DETAILED ACTION

Above figure- Applicants actuator.

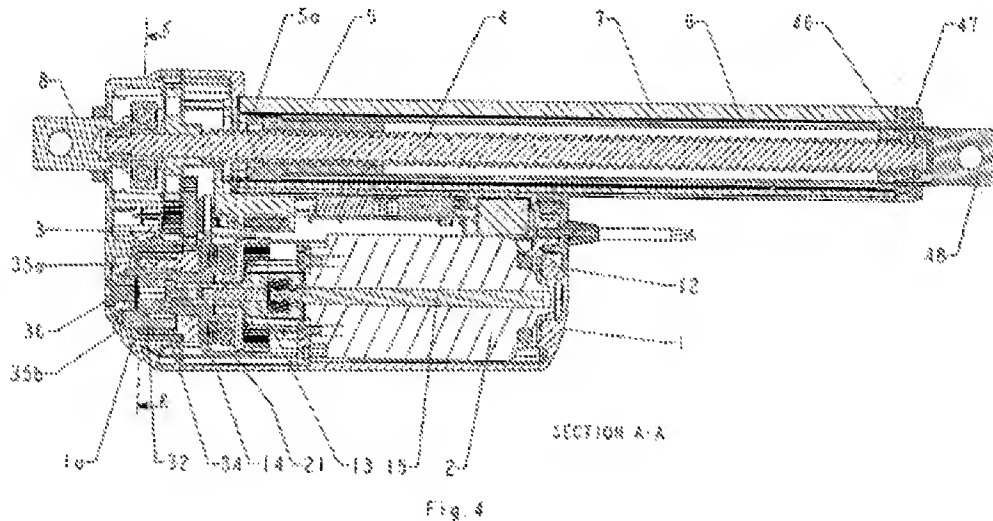
Applicant claims a linear actuator (fig. 1,10; Examiner notes prior art is a jack which has the same structure as the claimed actuator and functions as a linear actuator) comprising:

- A cabinet (fig.1, 22 or 24) having
- A reversible electric motor (fig. 2, 60 and col.6, lines 24-25; Examiner notes an electric motor is clearly capable of being reversible by switching the current) with a motor shaft (fig.2, 62),

- A reduction gear (fig.2, 64,66,76), where a first stage (fig.2, 64) is connected with the motor shaft as seen in fig.2,
- A spindle (fig.2, 88) whose one end is connected with an output side on the last stage of in the reduction gear (fig.2, 76) and the other end indicates the front of the actuator,

- A spindle nut (fig.2, 114; Examiner notes, prior art calls this a ball follower since its a ball screw) secured against rotation and translates linearly along the spindle (col.6, lines 13-15),

- A rear mount (fig.1, 14 and 20)
- An overload clutch (fig.2, 82, and col.6, lines 56-58) wherein the overload clutch is connected to one of the first stages in the reduction gear (fig.2; connected to gears 76,66,64).

Above figures- Whittingham's invention.

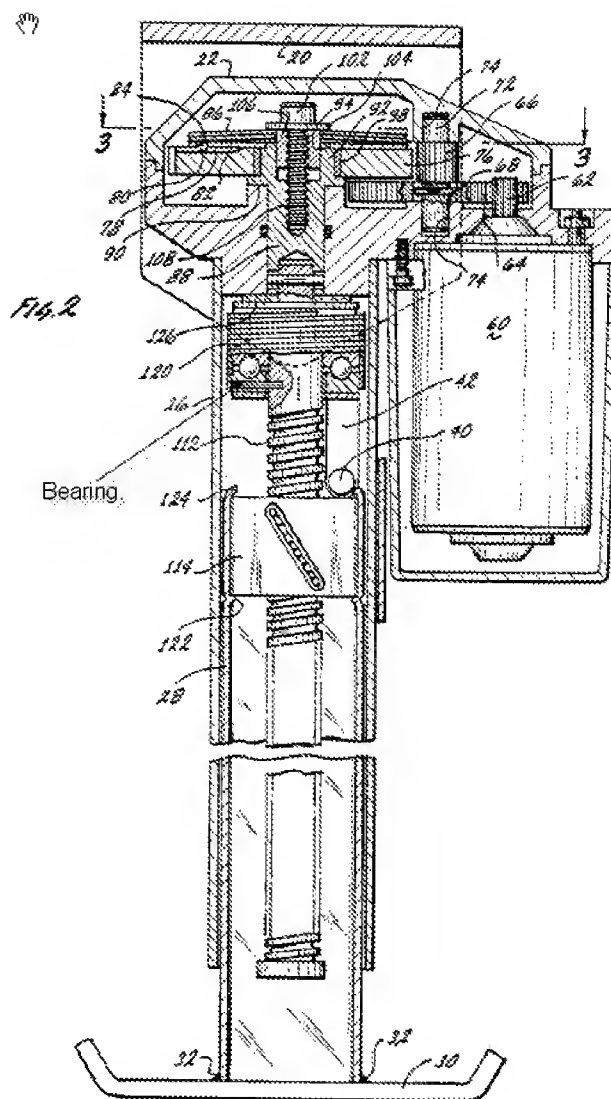
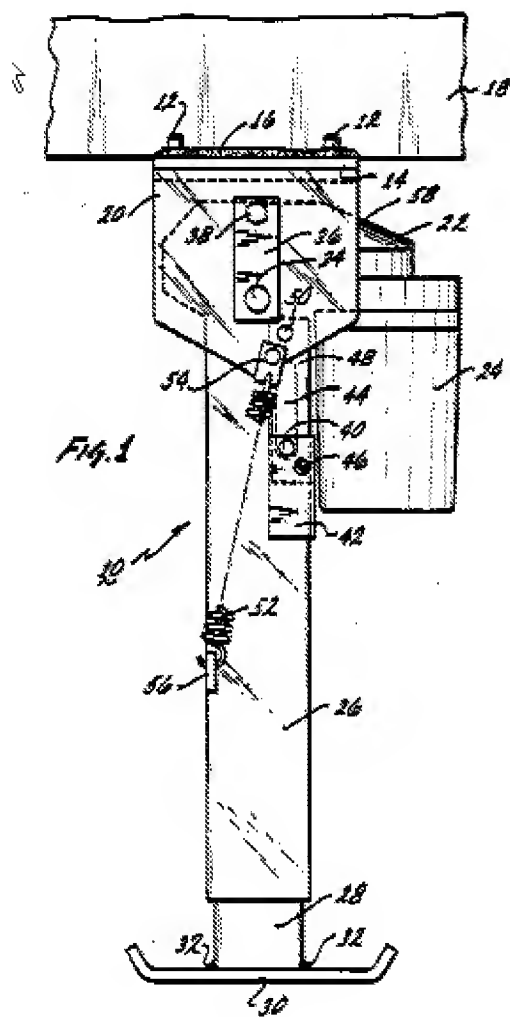
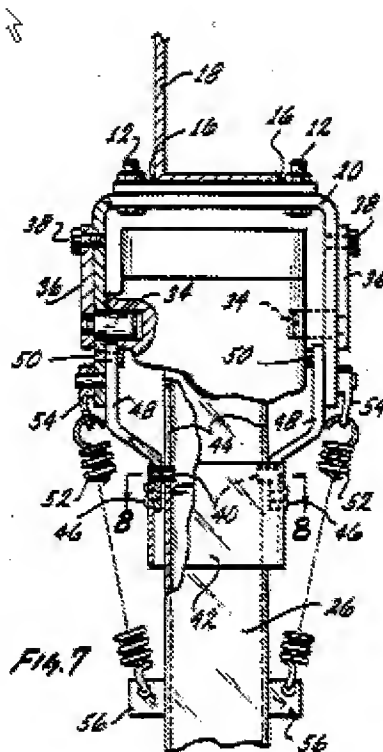
Applicant claims that the rear mount and a bearing (fig. 2, labeled by examiner) are secured in a mounting element (fig.1, 20) consisting of two parts (fig.7, 36) which are mounted in a depression in the cabinet (fig.7, shows how element 36 is mounted through pins 34 into the depressions in the cabinet) and secured with a nut (fig.7, 12) screwed on to the part of the rear mount that protrudes through the cabinet (fig.7, element 20 is part of mount that protrudes the cabinet as described above).

Above figure- Whittingham's invention.

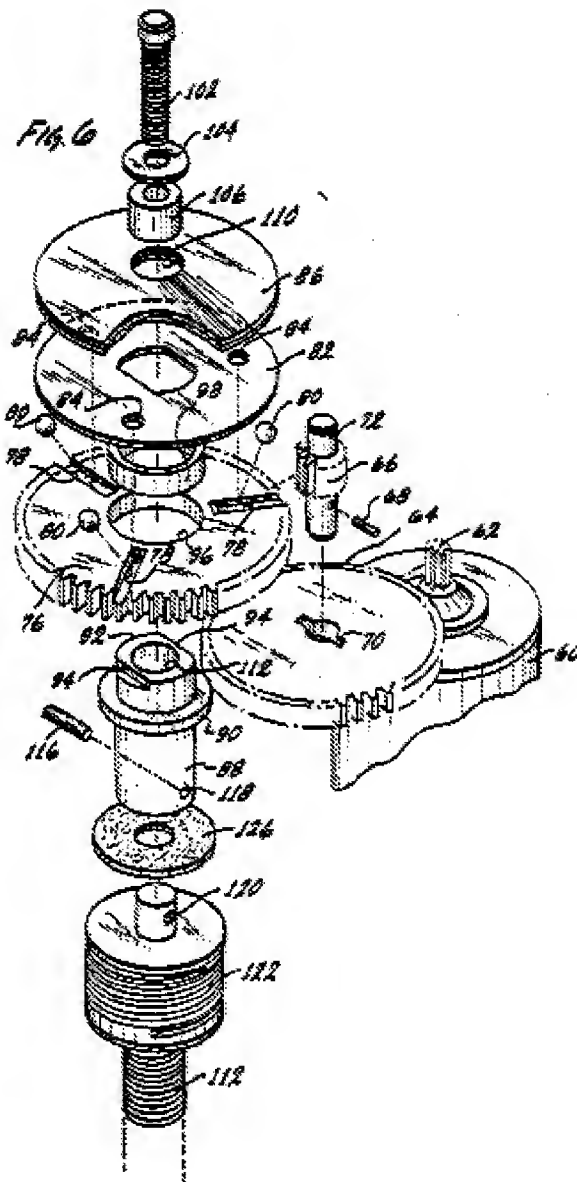
Applicant claims the overload clutch is a ball and ratchet clutch (fig.2; Examiner notes the prior art doesn't call their clutch by the same name but it has the same structure and therefore is the same type of clutch) comprising:

- a ring with holes (fig.6, 82)
- a first plate (fig.6, 76) with depressions (fig.6, 78) that engage the balls (fig.6, 80) and is firmly connected to the transmission from the motor (fig.2, the gear 76 is connected to the transmission of the motor),
- a second plate with depressions that engage another side of the balls which Whittingham fails to disclose,
- a spring mounted against the ceiling in a cap (fig.2, spring 86 mounted against the ceiling of a cap 94. Examiner takes the position that washer 94 acts as a cap on the spring because it covers it.),
- wherein the cap is secured indirectly to the first plate member (seen in fig.2, the cap is secured to the first plate member through bolt 102), and
- wherein the ring with the balls is connected with the further transmission to the spindle (fig.2, gear 76 being part of the transmission and the spindle is disposed through the ring.)

FIG. 9
(PRIOR ART)

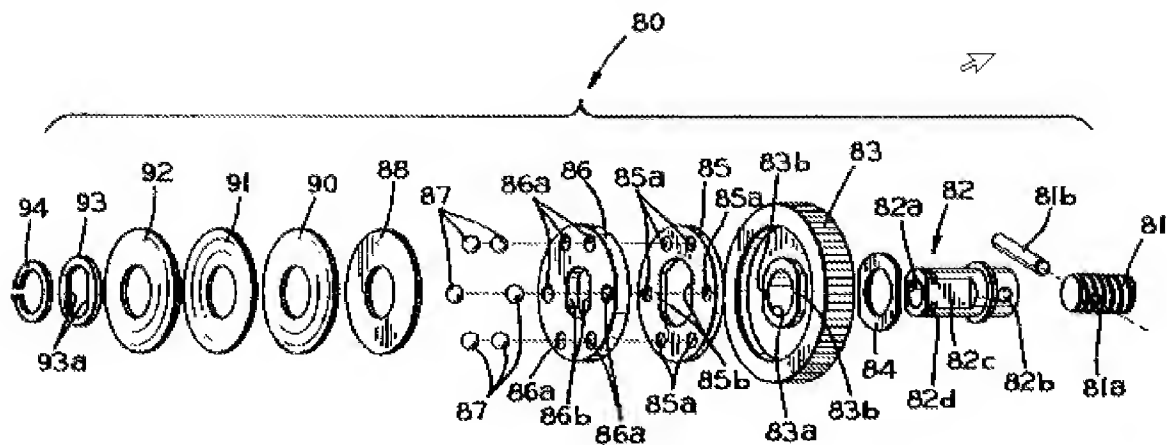
Alfano et al. teaches a linear actuator having a similar clutch system (fig.9) to the applicant's claimed invention for the purpose of limiting the amount of torque that can be transmitted from the motor to the screw assembly (see abstract) comprising:

- a ring with holes (fig.9, 83, The gear has hole for the balls and the clutch plates.)
- a first plate (fig.9, 85) with depressions (fig.9, 85a) that engage the balls (fig.9, 87) and is firmly connected to the transmission from the motor (fig.9, the gear 83 is connected to the transmission of the motor),

- a second plate with depressions that engage another side of the balls (fig.9, 86 and 86a),
- a spring mounted against the ceiling in a cap (fig.9, springs 90-92 mounted against the ceiling of a cap 94. Examiner takes the position that retaining ring 94 acts as a cap on the spring because it covers it.),

- wherein the cap is secured indirectly to the first plate member (seen in fig.9, the cap is secured to the first plate member the other members of the clutch assembly), and

- wherein the ring with the balls is connected with the further transmission to the spindle (fig.9, gear 83 being part of the transmission and a spindle (fig.9, 81) is connected to the gear 83.)

Above figure- Akkerman's actuator.

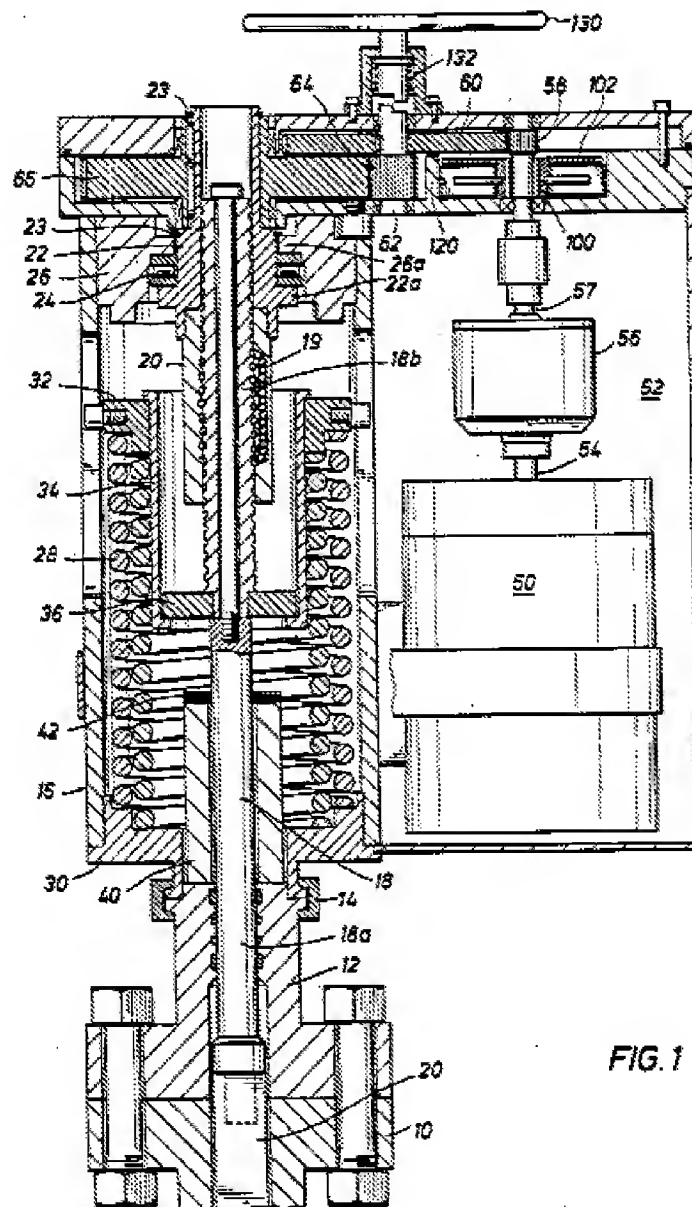
Akkerman teaches a valve actuator configured with an opening in the housing for a crank (fig.1, 130) in order to provide a way to manually operate the actuator in case the electric motor fails (col. 5, lines 66+, col. 6 lines 1-2).
